# ACCELERATED DISTRIBUTION DEMONSTRATION SYSTEM

SUBJECT: Forwards annual update of topical QA rept (TQAR), consisting of changes to TQAR, per 900612, marked-up version of TQAR last submitted, reflecting changes made & current TQAR, including revs issued through Rev 25 dtd 910605.

Re: Turkey Point Units 3 and 4  
Docket Nos. 50-250 and 50-251  
St. Lucie Units 1 and 2  
Docket Nos. 50-335 and 50-389  
Topical Quality Assurance Report (FPLTOAR 1-76A)

Florida Power & Light  
Topical Quality Assurance Report  
Change Summary  
June, 1991

TOPICAL QUALITY ASSURANCE REPORT	NRC MARKUP
ORGANIZATION OF DEPARTMENTS AFFECTING QUALITY FIGURE 1-1 APPENDIX A NUCLEAR DIVISION	06/10/91
	PAGE 1 OF 2

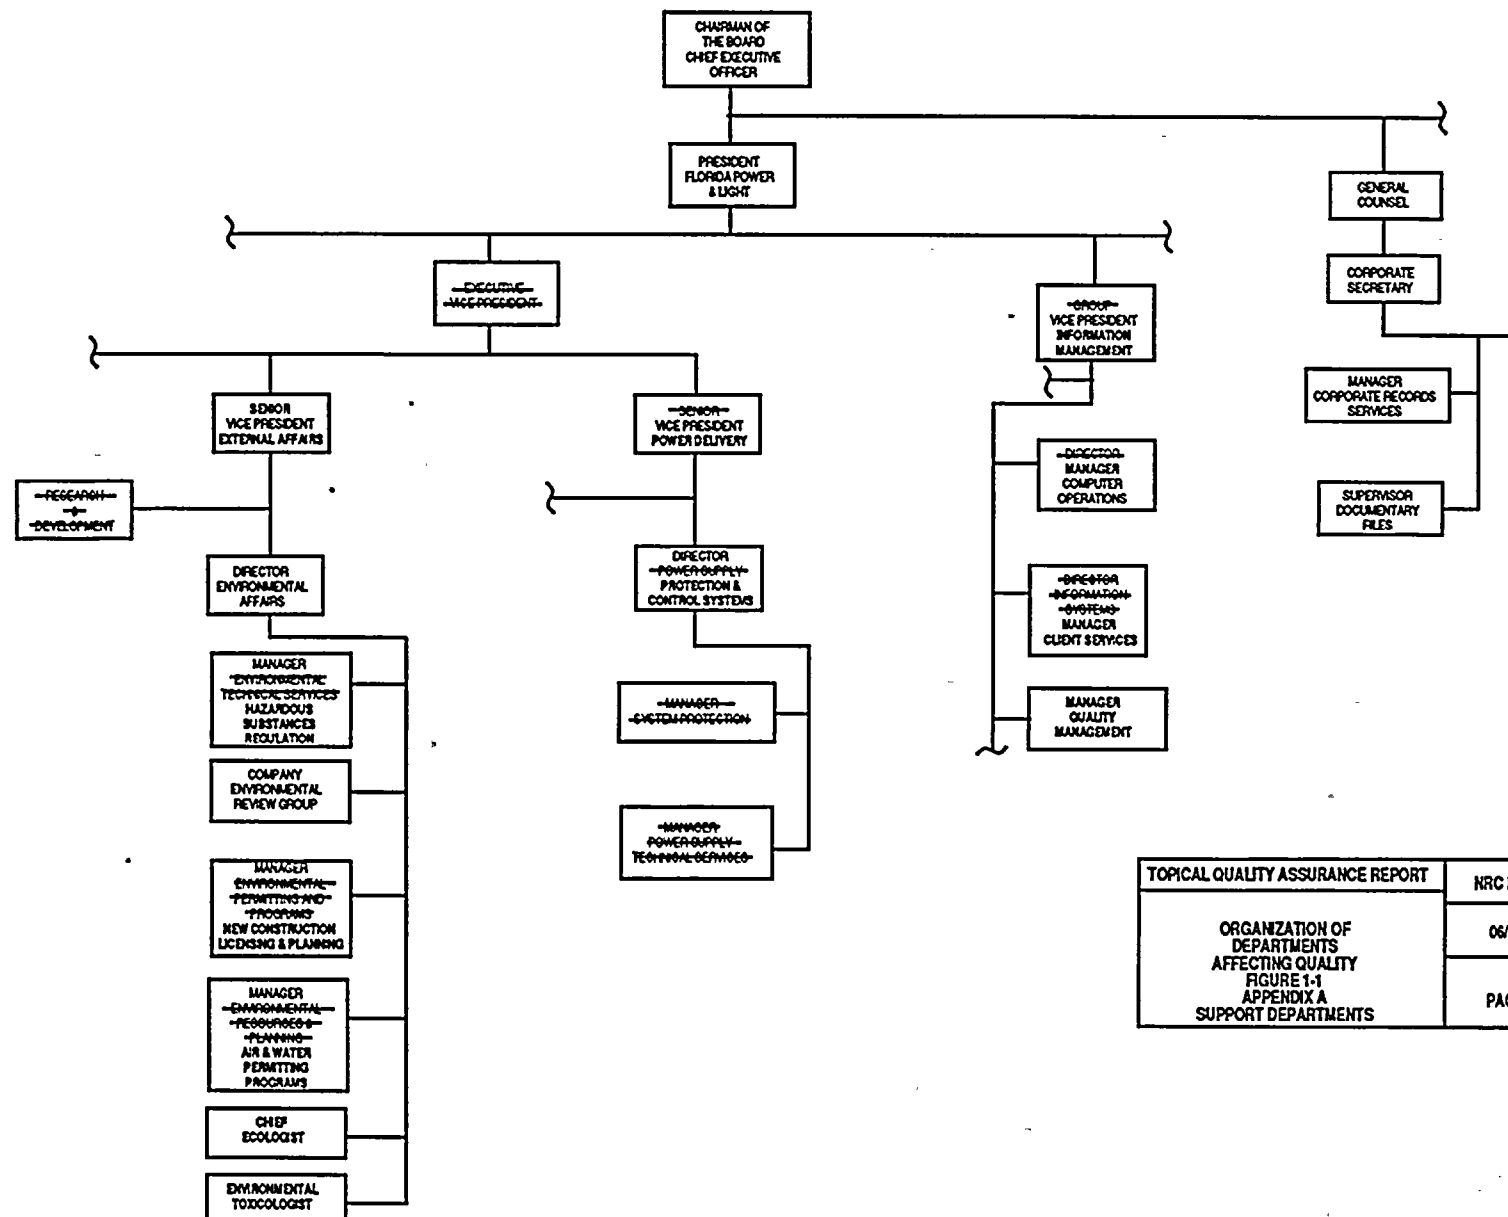
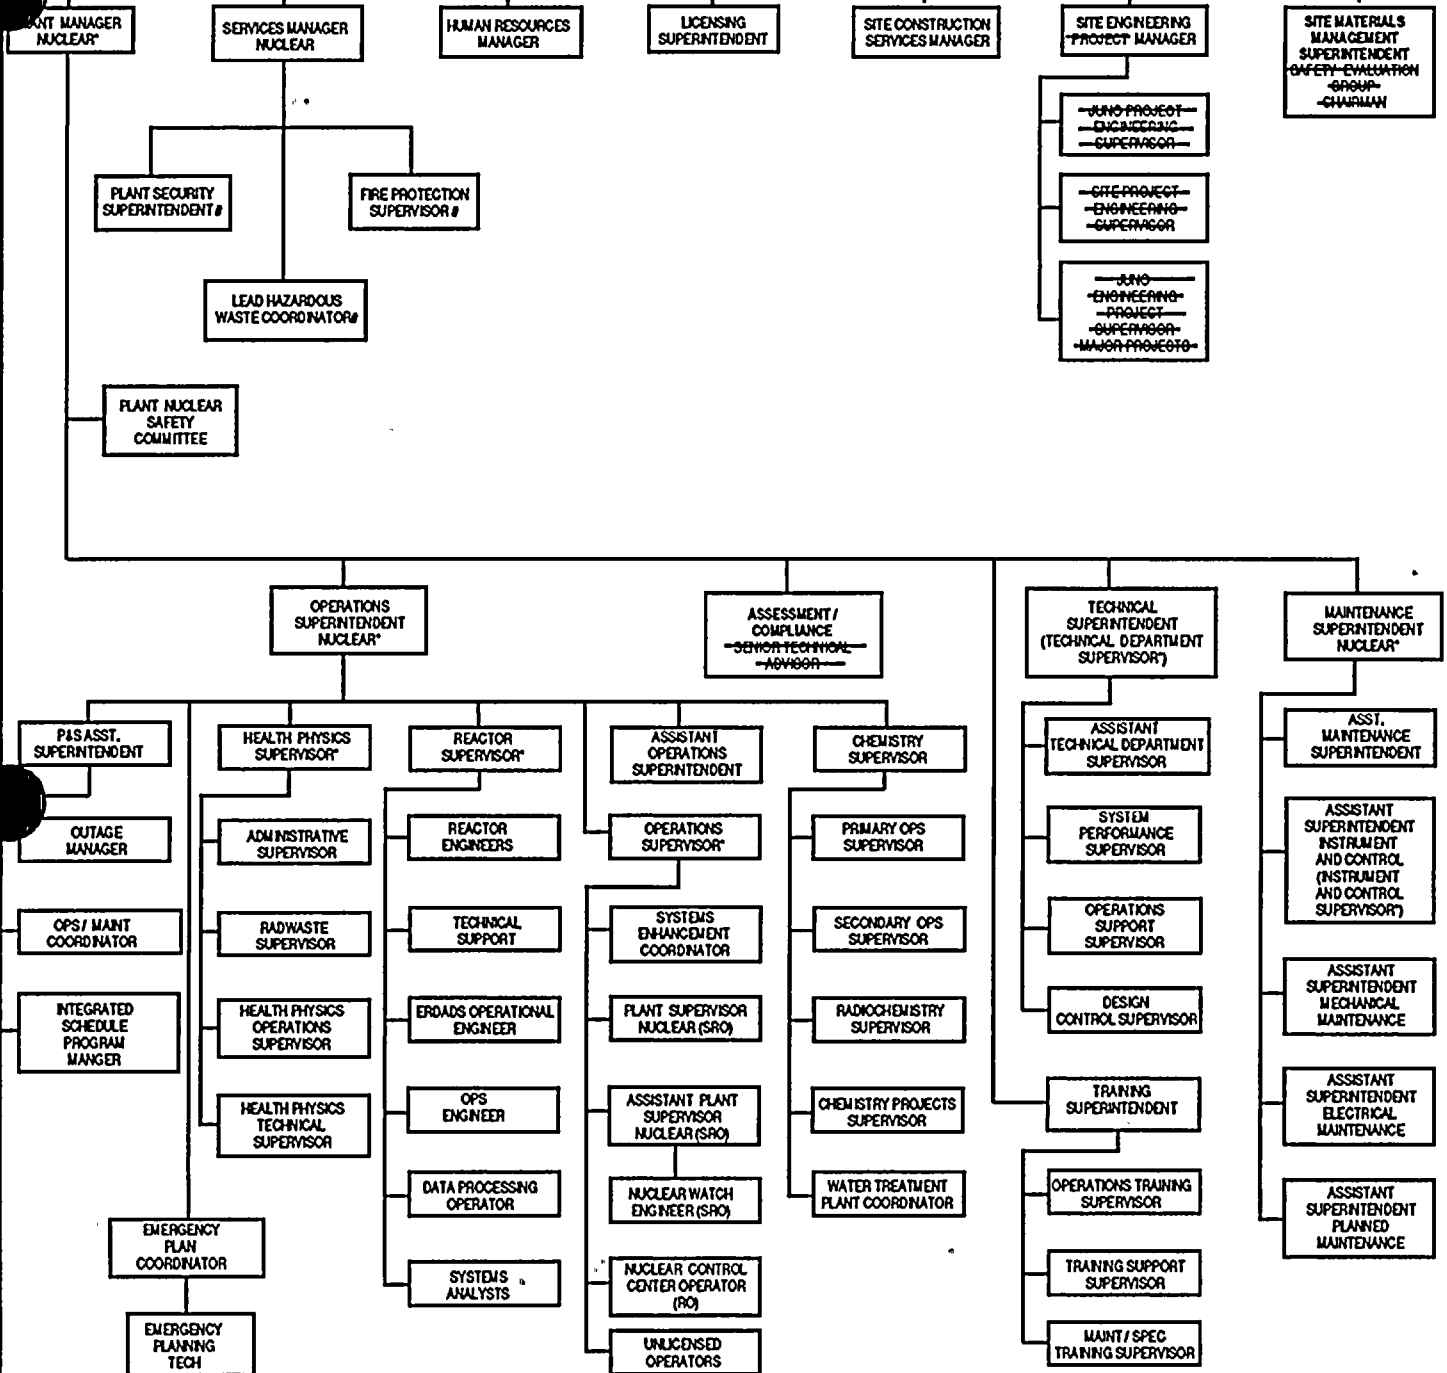
7. Appendix A, Figure 1-1 - Organization of Departments Affecting Quality Rev. 16 to Rev. 17

Page 1 of 1 was revised to reflect the changes described in TQR 1.0, Rev. 19, affecting the Nuclear Administrative Services Department.

8. Appendix A, Figure 1-1 - Organization of Departments Affecting Quality Rev. 17 to Rev. 18

Revised to reflect the new organizational structure described in TQR 1.0, Revision 20.

TOPICAL QUALITY ASSURANCE REPORT	NRC MARKUP
TURKEY POINT NUCLEAR SITE ORGANIZATION FIGURE 1-2 APPENDIX A	6/10/91
	PAGE 1 OF 1

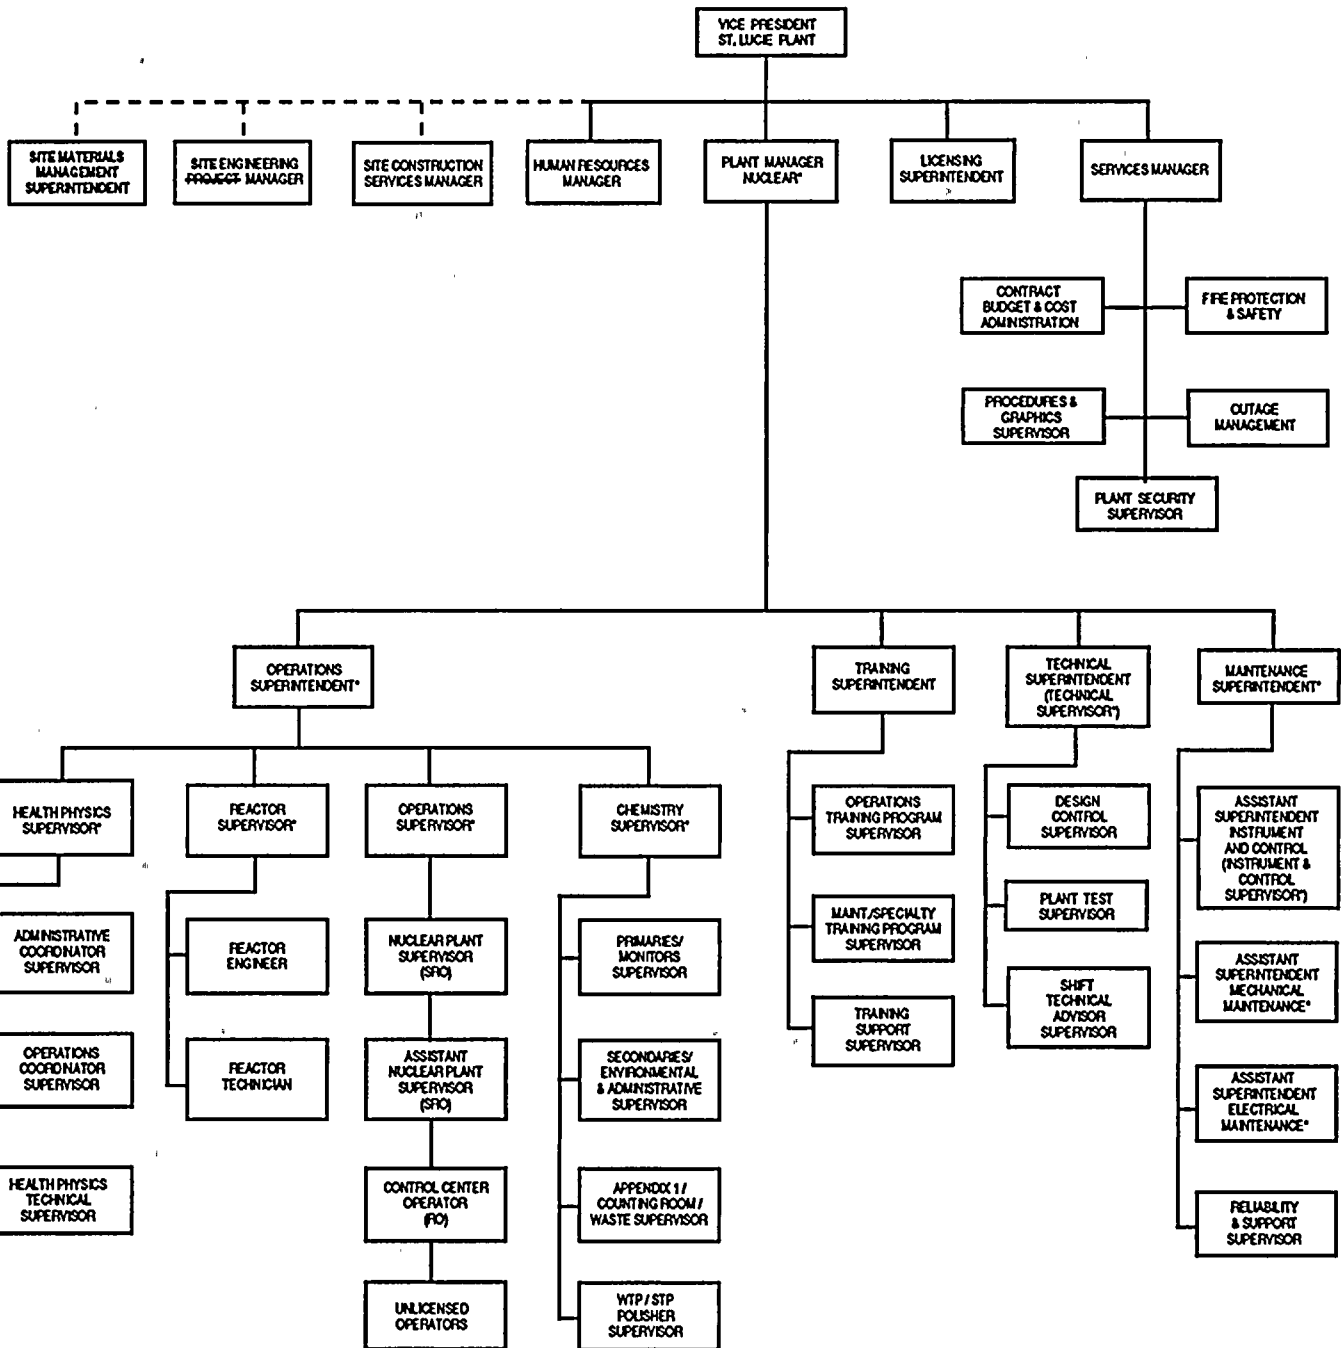
9. Appendix A, Figure 1-2 - Turkey Point Nuclear Site Organization Rev. 3 to Rev. 4

Revised to reflect the new organizational structure at Turkey Point Nuclear Plant as described in TQR 1.0, Revision 20.
